SERVICE BULLETIN

M-1401

PRODUCT PROGRAM 0919: 2015 STREET MODELS RIGHT SIDE RIDER FOOT CONTROL MOUNTING SCREWS

Figure 1. Right Side Rider Foot Control Assembly

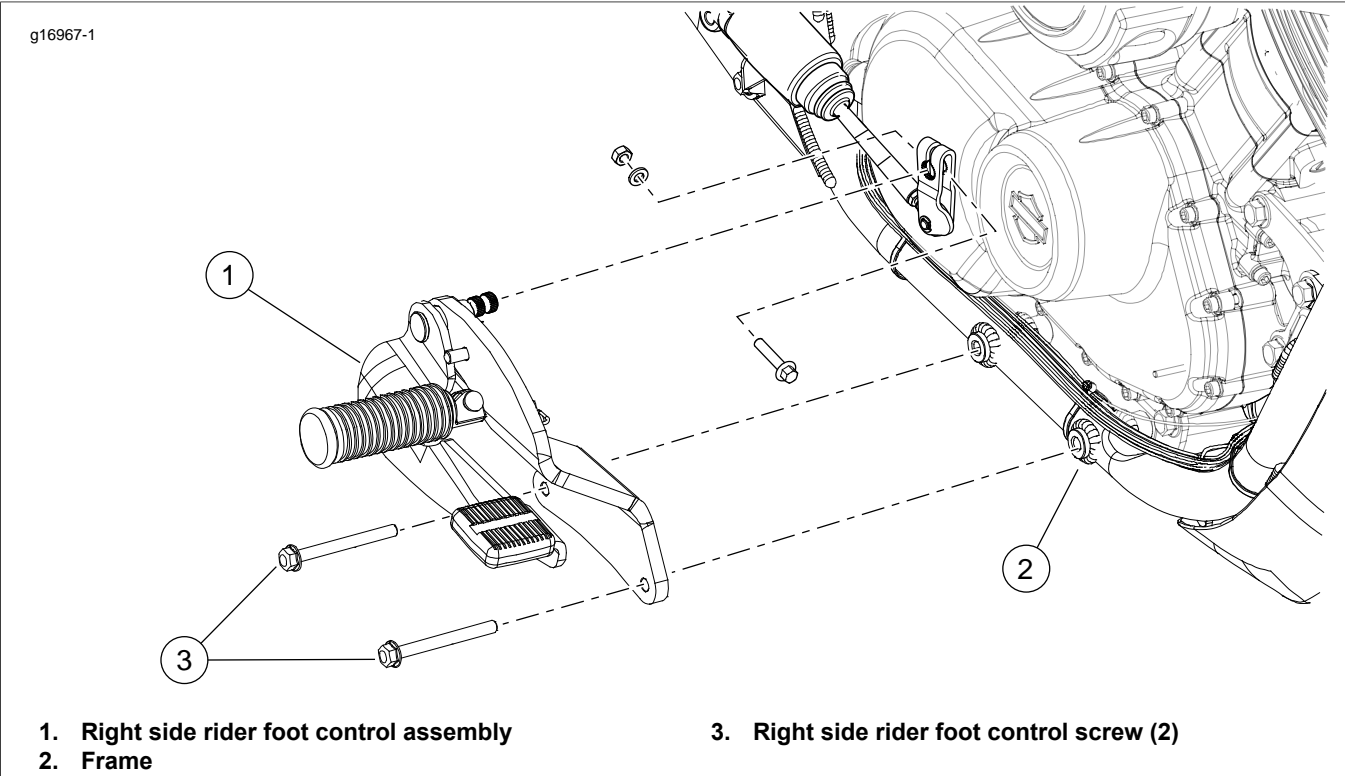
2. See Figure 1. Loosen both right side rider foot control mounting screws (3).
3. Retighten screws to 22.0-29.0 Nm (17-21 ft-lbs).
